Work Order ID 149109

Item ID: D4634-143 Accept ***N900040100*** Setup Start ***NS1***
Revision ID: Stop ***NS2***
Item Name: Middle, Center Ceiling Replacement Panel Assembly
Start Date: 7/13/2016 Start Qty: 1.00 ***1*** Cust Item ID:
Required Date: 7/19/2016 Req'd Qty: 1.00 ***1*** Customer:
Reference:

Work Order: 149109	DISPOSITION Rework ☒ Scrap ☐ Use-as-is ☐ Suspected Unapproved ☐	AGAINST DEPARTMENT/PROCESS					
Part No. 04634-143		Skid-tube ☐	Cross tube ☐	Water Jet ☐	Engineering ☐		
NCR No. 16-5994		Machining ☐	Small Fab ☒	Prod. Eng. Coord. ☐	Quality ☐		
		Thermoforming ☐	Finishing ☐	Rec/Store/Packaging ☐	Other ☐		
		Large Fab ☐	Composite ☐	Supplier ☐

D4634-143 MIDDLE, CENTER CEILING REPLACEMENT PANEL ASSY

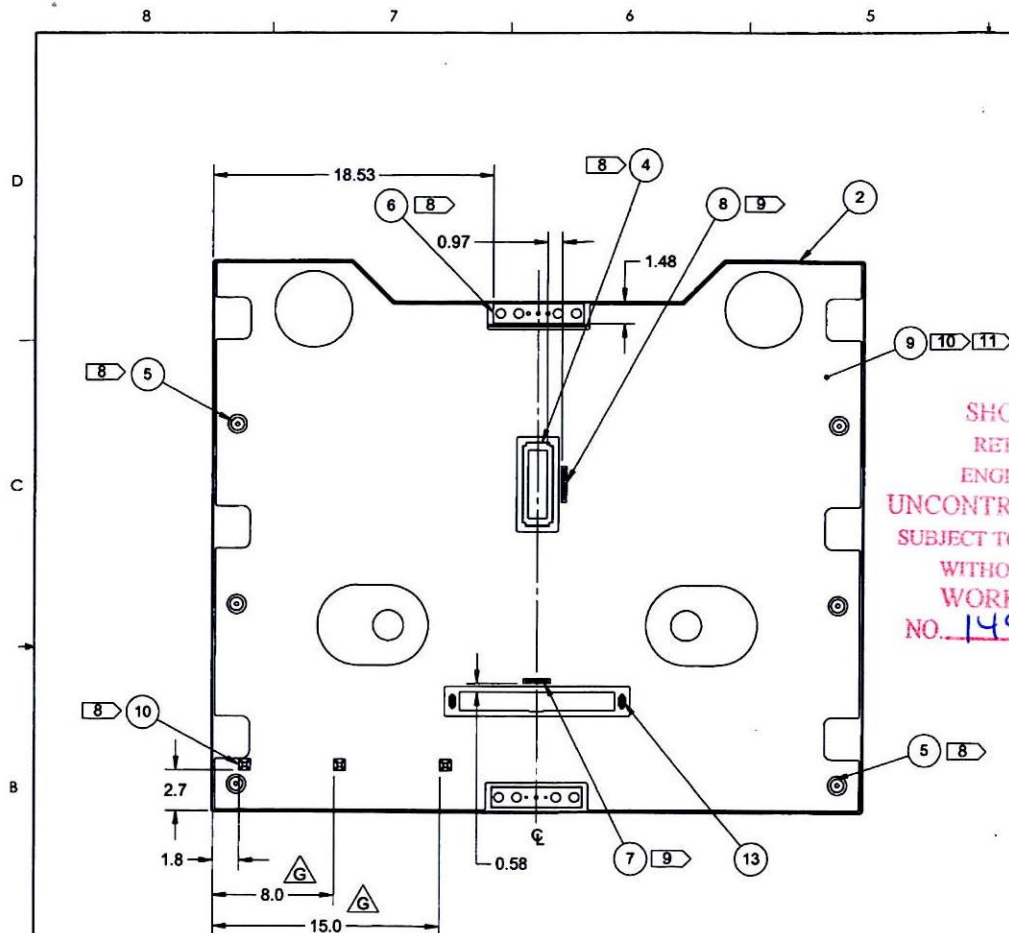
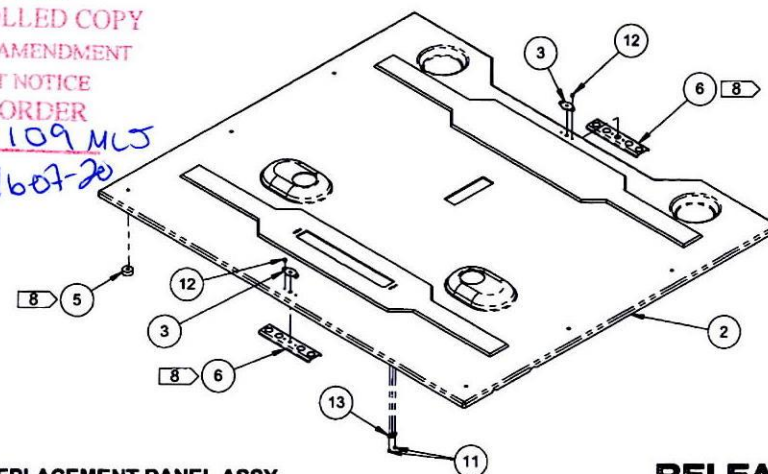
Description Work Order Deviation	Disposition	Completed-By AUG 22 2016 27 9-89
WHILE INSTALLING MS20426AD 3-6 RIVETS THE RIVET WOULD NOT INSTALL WITHOUT DAMAGING LEXAN MATERIAL CAR REQUIRED CAR 46-153	REMOVE MS20426AD 3-6 RIVETS AND INSTALL CCR 264SS-3-03 RIVETS. (QTY 4) M135123	Lead hand / Supervisor Approval Verification DAS 9 9-89 160822
		QC / QA Coordinator Approval DAS 9 9-89 160822

I saw the problems he was having and suggested to replace the rivets as a production tweek. I assessed the situation and suggested using an Anchor Nut Rivet (CCR264SS-3-03) when replacing the unacceptable rivet he showed me.

The fix would be to manufacture two small doublers (Picture:133104 and 133053) from 6061T6 0.020 Aluminum and dimple the top side, alodine, then sandwich the Lexan between the two doubles and bond in place, while attaching the Anchor Nut with CCR264SS-3-03.

It is acceptable the modification your suggested adding doublers and CCR264SS-3-03 as an alternate to the MS20426AD3-6 rivet for the product is on production to fix the issue.
